DEVELOPMENT ASSESSMENT REPORT	
<b>Application No.</b>	REV/2022/0035
<b>Address</b>	237 Marrickville Road MARRICKVILLE NSW 2204
<b>Proposal</b>	S8.2 Review of DA/2022/0069, refused on 14 September 2022, for alterations to the existing first floor for use as a dwelling
<b>Date of Lodgement</b>	18 November 2022
<b>Applicant</b>	Design Studio 407 Pty Ltd
<b>Owner</b>	Mrs Dimitra Karagiannis
<b>Number of Submissions</b>	1
<b>Value of works</b>	\$150,000.00
<b>Reason for determination at Planning Panel</b>	Refusal of Section 8.2 review
<b>Main Issues</b>	Solar Access and Waste Management
<b>Recommendation</b>	Refusal
<b>Attachment A</b>	Plans of proposed development
<b>Attachment B</b>	Draft conditions in the event the application is approved
<b>Attachment C</b>	Determination DA/2022/0069 dated 14 September 2022

## 1. Executive Summary

**Proposed Shadows for 8am, 9am and 10am**

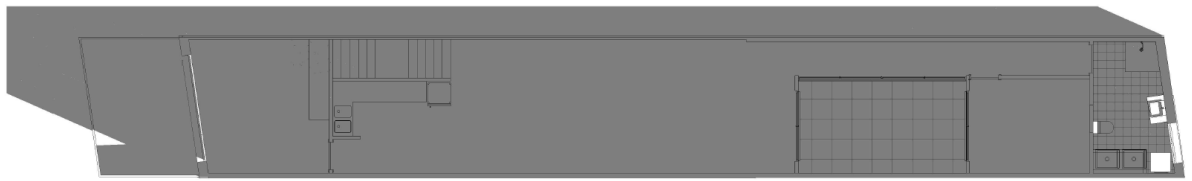
Whilst it is acknowledged the 8.2 review has revised the plans to try and address the solar access concerns, it is considered that solar access to the first floor remains severely constrained notwithstanding the slight improvement in sunlight access. It is still considered that neither the primary living areas nor the courtyard/POS achieves an appropriate amount of solar access that would be considered acceptable or conducive to a reasonable level of amenity for future occupants.

Based on the above it is still considered solar access remains a concern and still inconsistent with Part 2.7 of MDCP 2011. Whilst the amended plans result a slight improvement, the majority of the proposed first floor dwelling remains with very limited solar access throughout the day. This is considered a very poor amenity outcome for future residents and is not considered a form of development that is suitable given the severe solar access constraints. The review has also not provided shadow diagrams at the equinox to determine if there is an improvement in sunlight access during that period of the year. As such it is considered the revised proposal has not adequately addressed the solar access concerns as its fails to provide the minimum solar access required to principal living areas and the principal area of open space and cannot be supported.

The proposal is therefore inconsistent with O2, C1 and C9 of Part 2.7 and O7 and C26 of Part 2.18 of the MDCP 2011

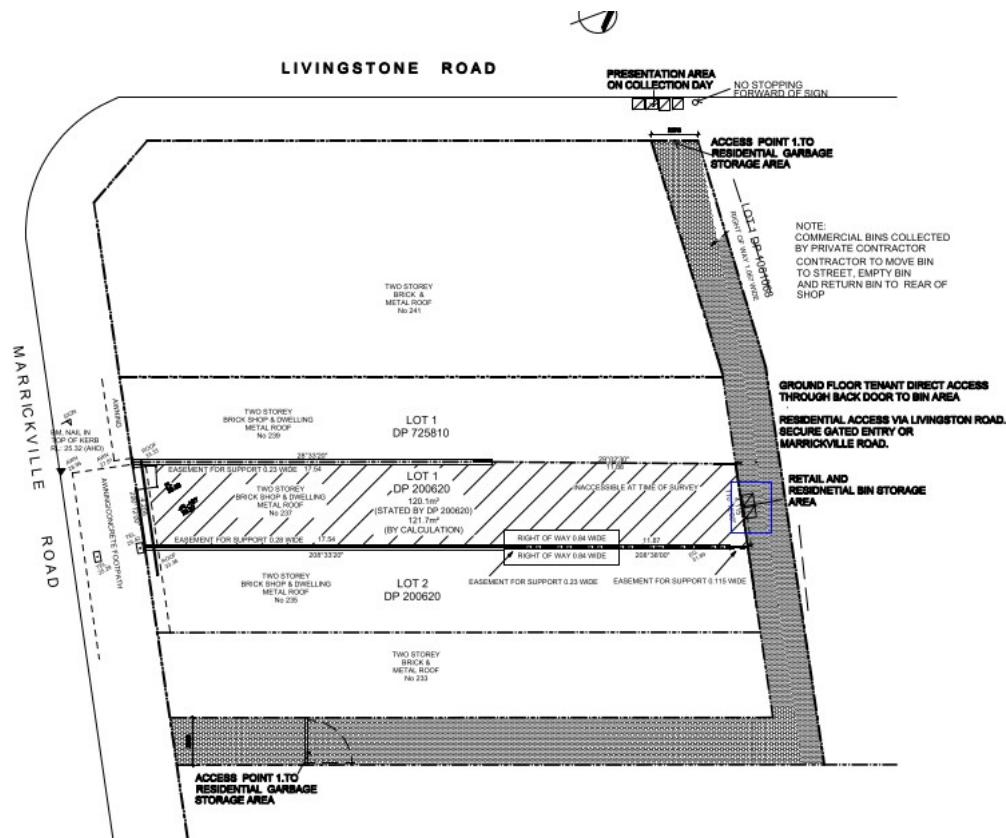
The original application had proposed the waste storage area to be located in the existing ROW to the rear of the site which was considered contrary to C10 and C12 of MDCP 2011 Part 2.21, as the proposed waste storage area was not located or designed in a manner which reduces adverse impacts upon neighbouring properties and on the appearance of the premises. The original application did not include separate residential and non-residential waste storage areas nor were the waste areas located in a designated waste storage area.

The original application also located the waste storage area outdoors and not suitably screened which did not comply with C13 of MDCP 2011 Part 2.21.

Moreover, the original application was considered unsatisfactory as the proposed recycling/waste storage area did not provide an unobstructed and continuous accessible path of travel between the recycling/waste storage area to the entrance of the proposed shop top housing, or to the point where bins are collected did not comply with C26 of MDCP 2011 Part 2.21. As the shop top dwelling is located on the first floor of an existing building, internal works would be required within the building to ensure that a route of transfer is provided that is free of obstructions such as steps, has a minimum wall to wall clearance of 1200mm and have a maximum gradient of 1:12. The original proposal did not demonstrate this option, and has relied upon legal details which have not been confirmed that the site benefits from using the ROW for the purposes of waste storage.

The originally proposed waste storage area was consequently considered inconsistent with C1 as it was not designed in accordance with appendix 4 of Part 2.21 of the MDCP 2011. At the time the proposal was not supported by Council's Waste Officers, from both a commercial and residential perspective.

To address this matter the amended plans submitted with s8.2 review that have propose additional alterations to the first floor to accommodate a garbage chute. The proposal locates two 500mm diameter chutes, accessed by a hinged top 900mm high cupboard housing the two chutes leading down to the location of the bins – located in a proposed garbage room. The garbage chutes are located within the proposed first floor bathroom. The waste storage area is to service both the ground floor and first floor tenancies.

The amended plans have also included a designated garbage room on the ground floor within the building envelope. The proposed garbage room is to have smooth surface finishes, perimeter coving, removable basket trap to floor waste, hot and cold-water supply and a solid core door fitted with fixed aluminium louvres for air circulation (as indicated on the revised floor plans).

The revised plans associated with the review were referred to Council's Waste Officer who has indicated the revised proposal remains unsatisfactory. The revised waste storage design still does not provide the ability to separate the residential and non-residential waste. The proposed design is to service both the ground floor commercial and the proposed first floor residential uses. This design is still considered non-compliant with C1 of Part 2.21 of the MDCP 2011 which requires the waste storage area to comply with Appendix 4 of Part 2.21. Appendix 4 requires non-residential development recycling/waste storage areas or rooms to be able to accommodate separate recycling/waste containers of sufficient size.

Moreover, as the proposal has not proposed separate commercial/residential waste area, the proposal does not comply with C46 and C47 of Part 2.21, which prescribes;

Given the above the proposed waste storage design is considered unsatisfactory and inconsistent with Part 2.21 of the MDCP 2011.
